Project	IEEE 802.16 Broadband Wireless Access Working Group < http://ieee802.org/16 >
Title	Ranging Primitive Example
Date Submitted	2006-09-28
Source(s)	Peretz Feder - Lucent Technologies [mailto: pfeder@lucent.com]
Re:	
Abstract	This contribution is an addendum to Appendix F
Purpose	Adoption
Notice	This document has been prepared to assist IEEE 802.16. It is offered as a basis for discussion and is not binding on the contributing individual(s) or organization(s). The material in this document is subject to change in form and content after further study. The contributor(s) reserve(s) the right to add, amend or withdraw material contained herein.
Release	The contributor grants a free, irrevocable license to the IEEE to incorporate material contained in this contribution, and any modifications thereof, in the creation of an IEEE Standards publication; to copyright in the IEEE's name any IEEE Standards publication even though it may include portions of this contribution; and at the IEEE's sole discretion to permit others to reproduce in whole or in part the resulting IEEE Standards publication. The contributor also acknowledges and accepts that this contribution may be made public by

Figure F9 – The use of Ranging Primitives

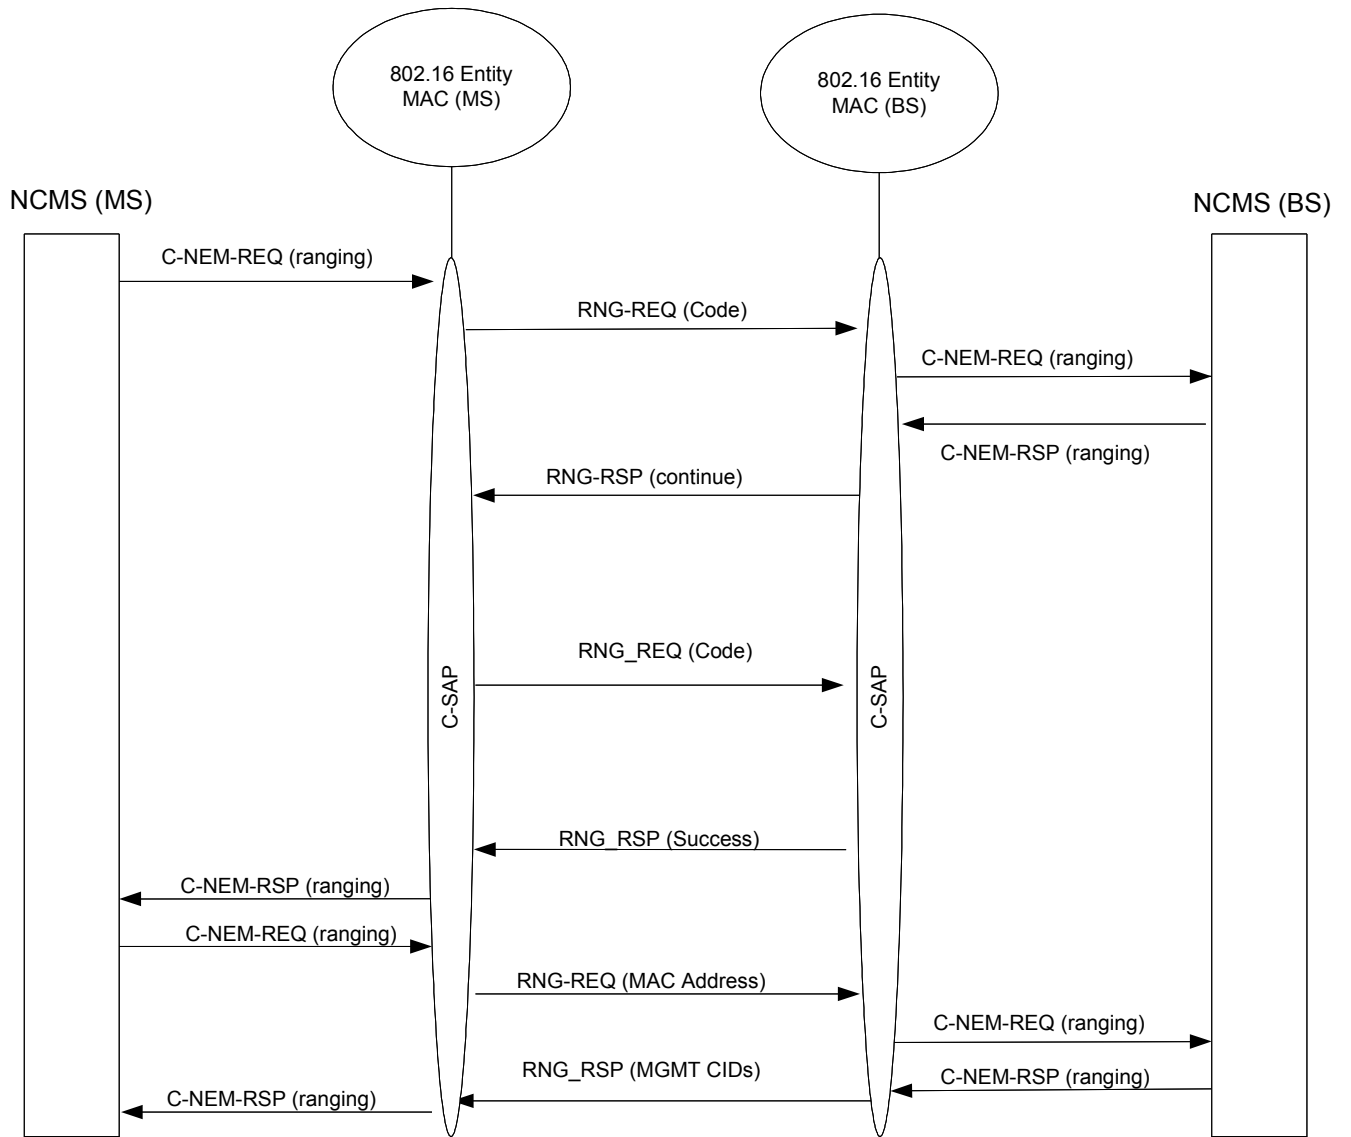
Add Section F.4

Add the following Figure to the Annex F
